Water management workshop summary

Held on : March 19th 2024

Troilus Gold understands the importance of water management and present and future land use to the projects cree stakeholders/rightholders. In an effort to be as transparent as possible as well as to gather and address concerns, questions and recommendations upstream of the Impact assessment study. The water management workshop regroups engineering, impact assessment consultants, Cree stakeholders and Troilus Gold representatives. The workshop is held to provide an overview of the Troilus Gold project to cree stakeholder/rightholders to address concerns/questions and receive recommendations to adapt the project according to comments received.

Surface Water Management Plan – Closure

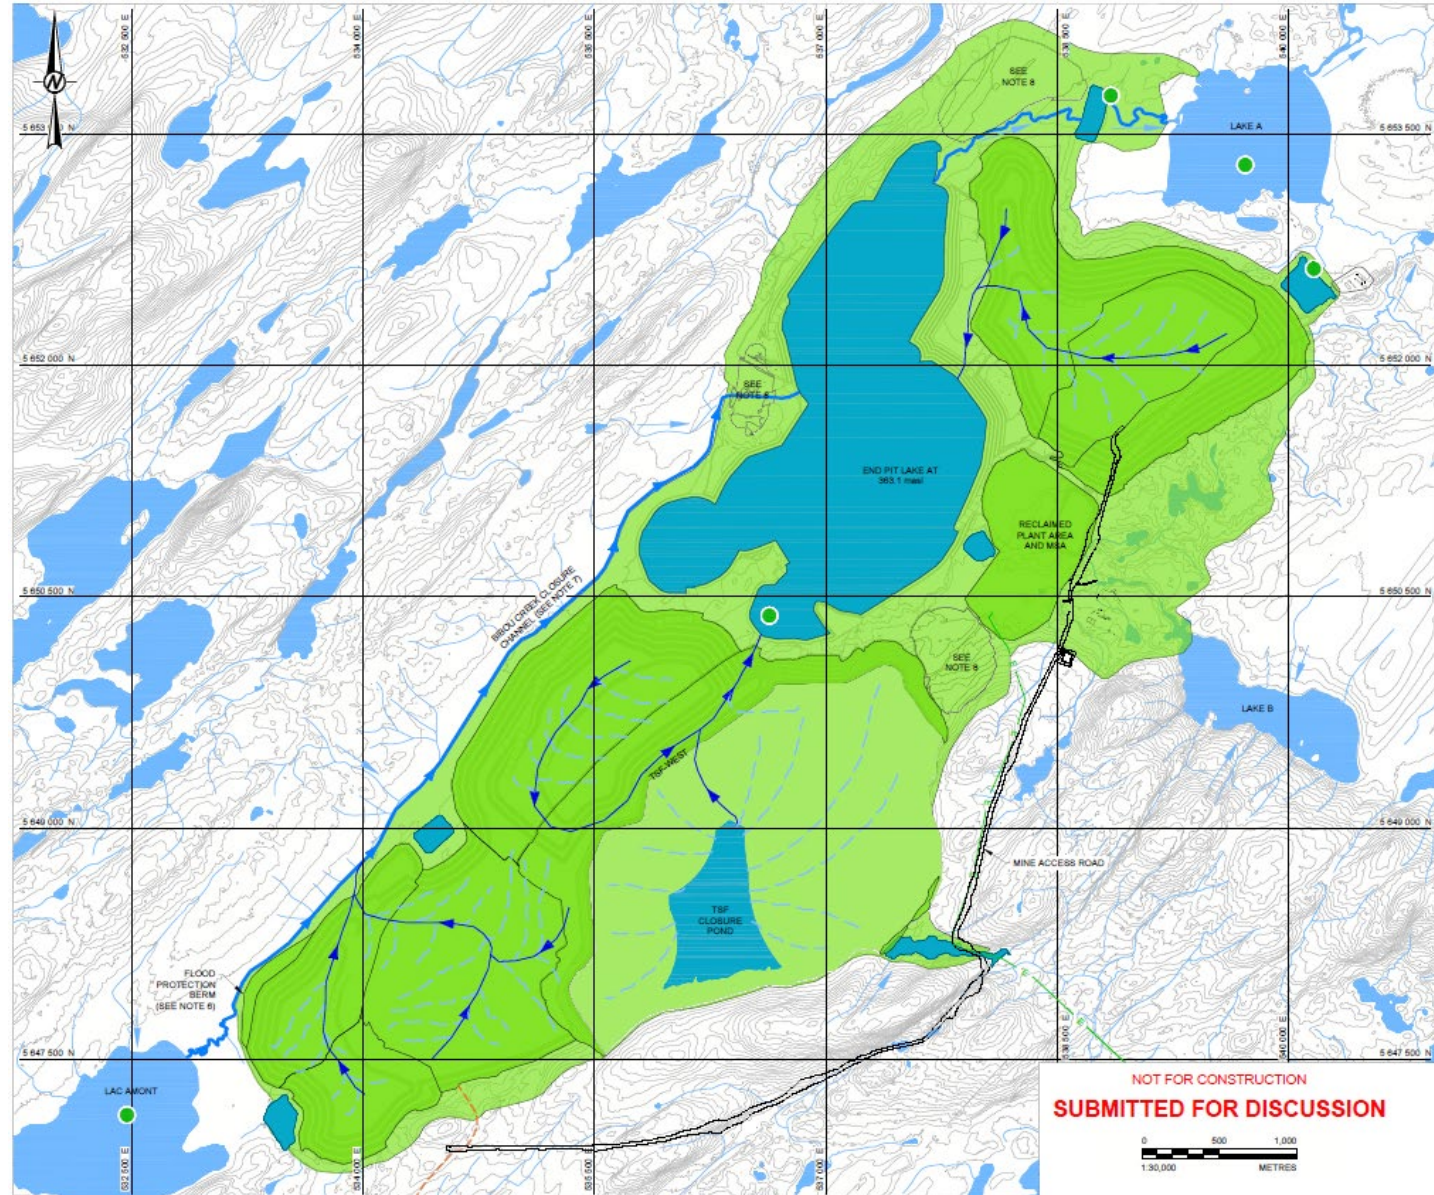
C: The point is to know what is going to happen with it at the end of closure.

C: How are the slopes of the channel?

C: What is the profile of the channel?

R: The closure plan will specify that. It is still in development. For now, the plan is for the area to be revegetated, and the slopes of the TSF would be reshaped. A channel would connect it in the north to the pit lake.

R: The slopes are planned to be 2:1.

R: It is a concept of rock ramps with 2% slopes, which are fairly mild, and allow the fish to swim where water velocity would be high without the ramp.
